Re: Bid # 071TB58420K-RS Riverside Road Pump Station Upgrade

ADDENDUM No. 5

ADDENDUM NO. 5	DATE 01-24-08	Mechanical Yard Piping Plan		H & S JOB NUMBER 30039	REFER TO CONTRACT DRAWING NUMBER M1
ATTACHMENT NO. MSK-1	BY H & S	RIVERSIDE ROAD PUMP STATION UPGRADES		CONTRACT NUMBER .	SHEET 1 OF 1

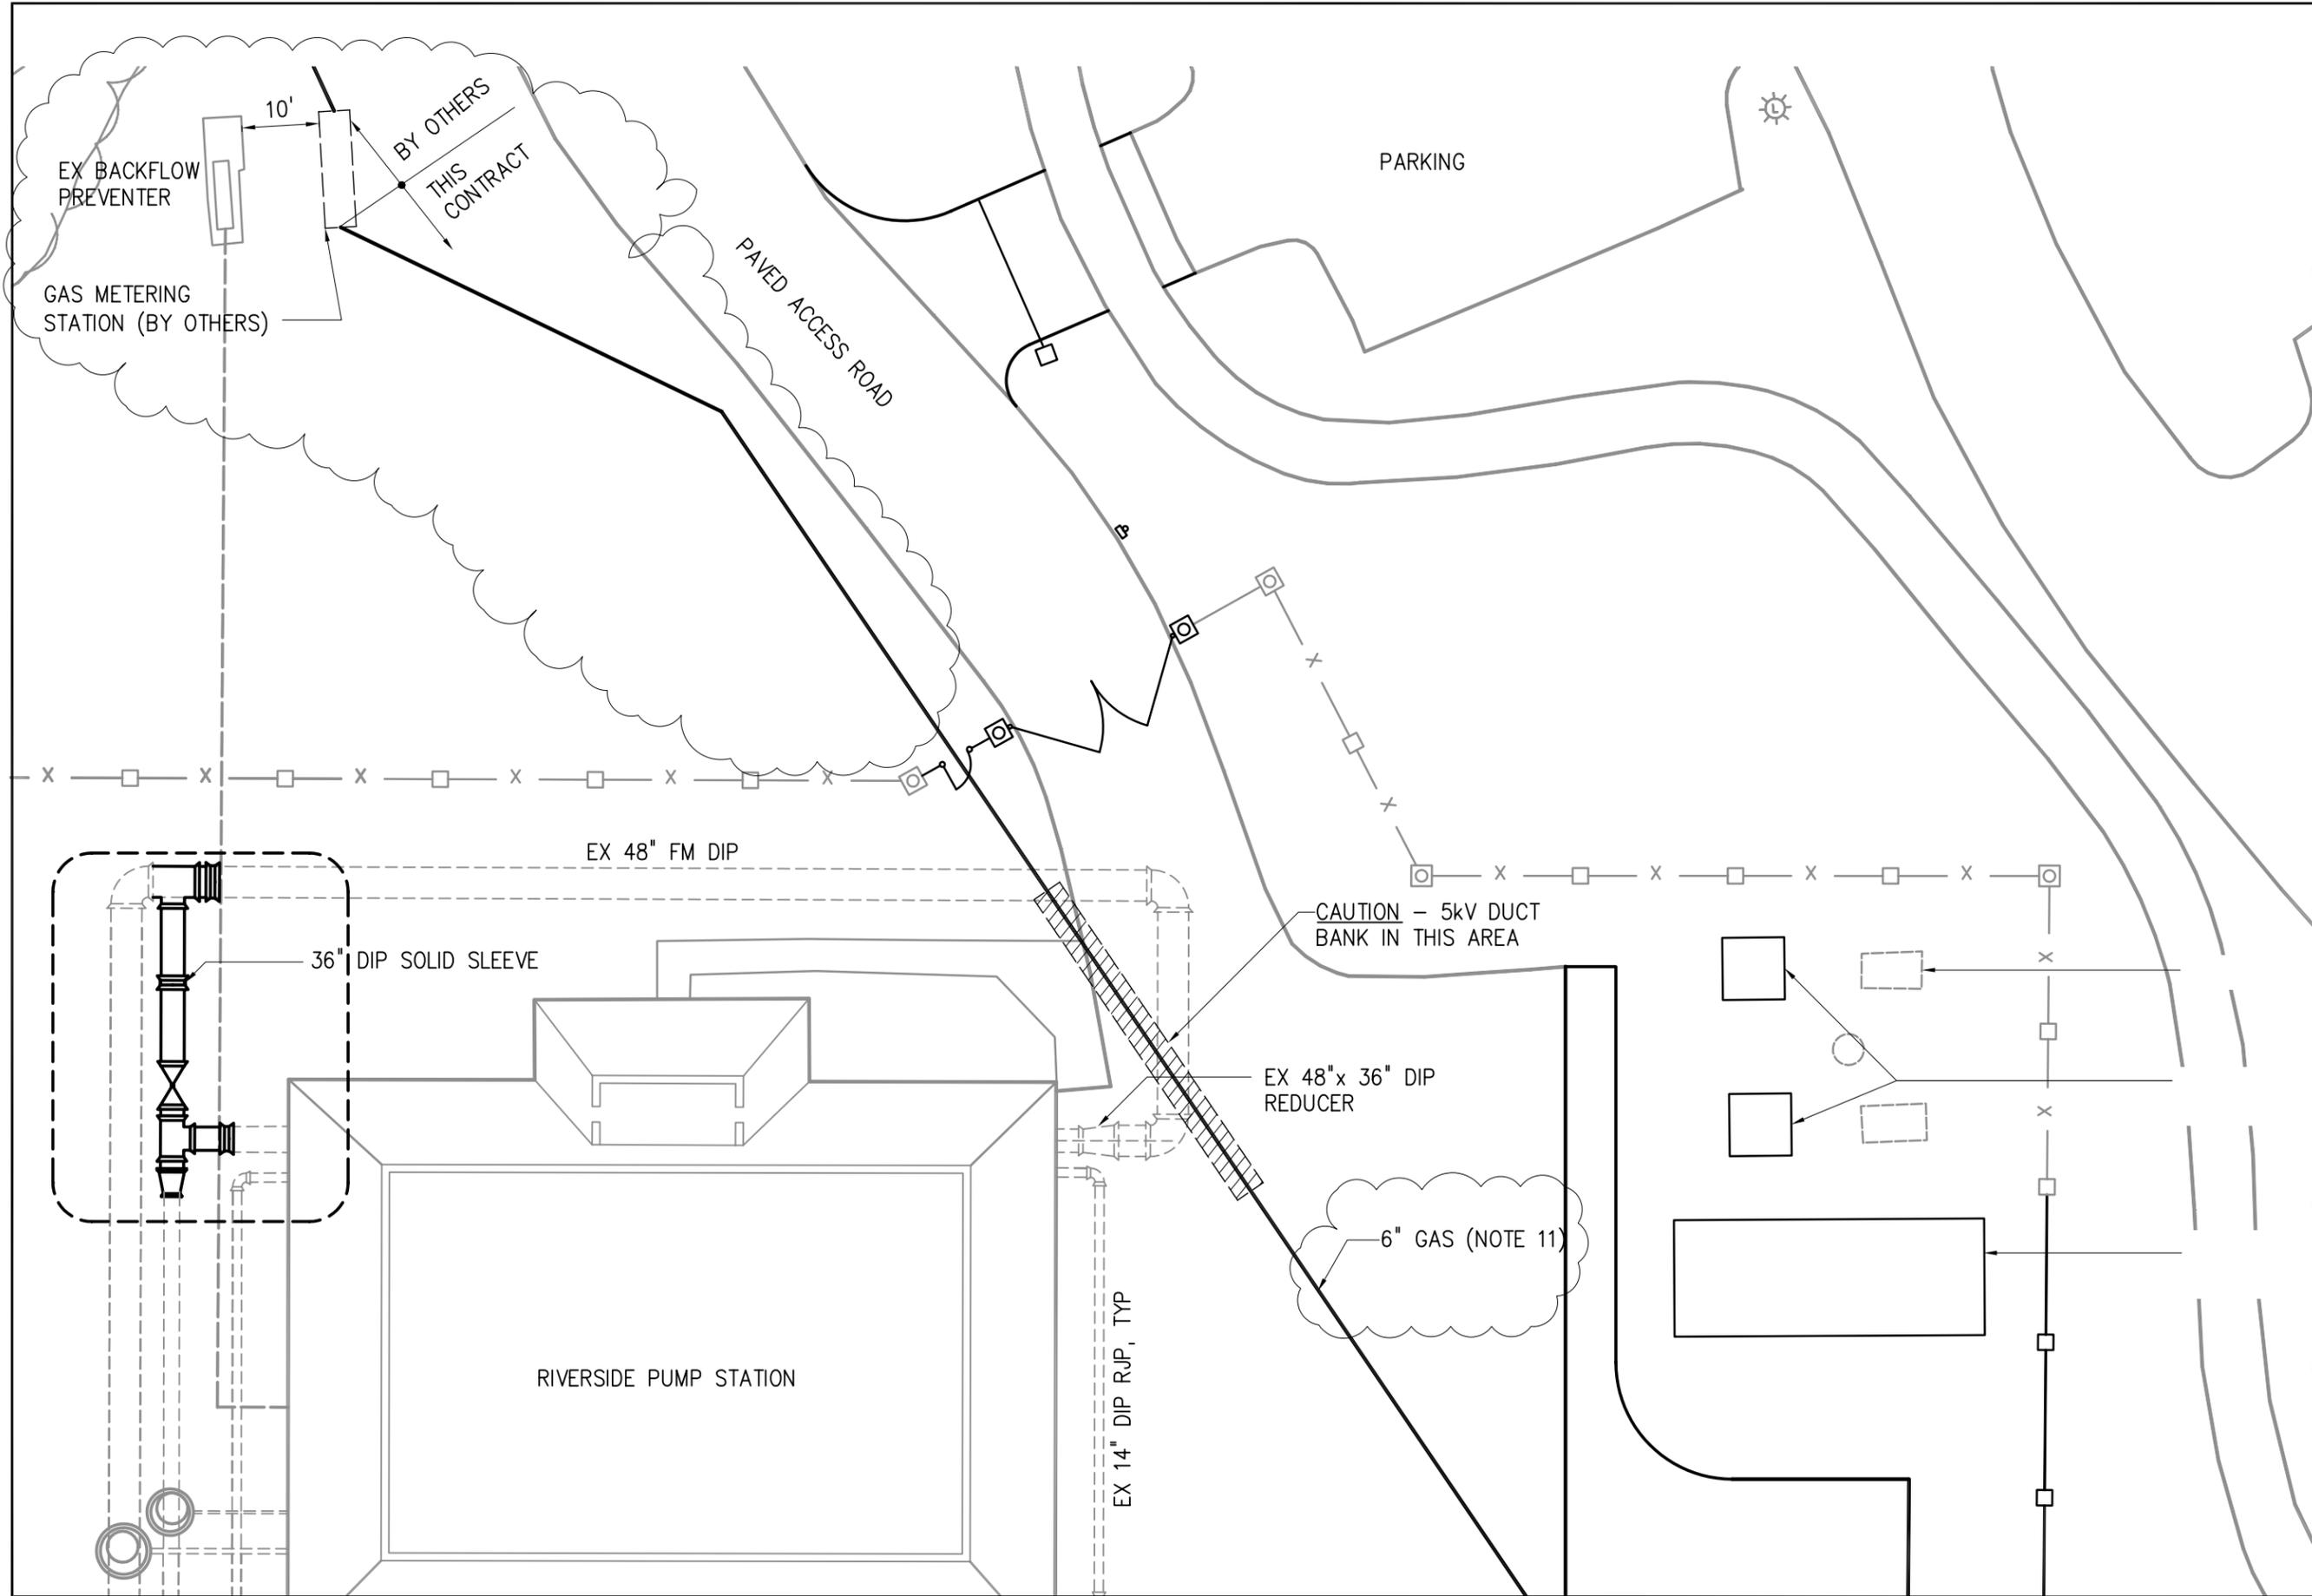
Item 1: Revise Drawing M1 in accordance with the attached sketch MSK-1.
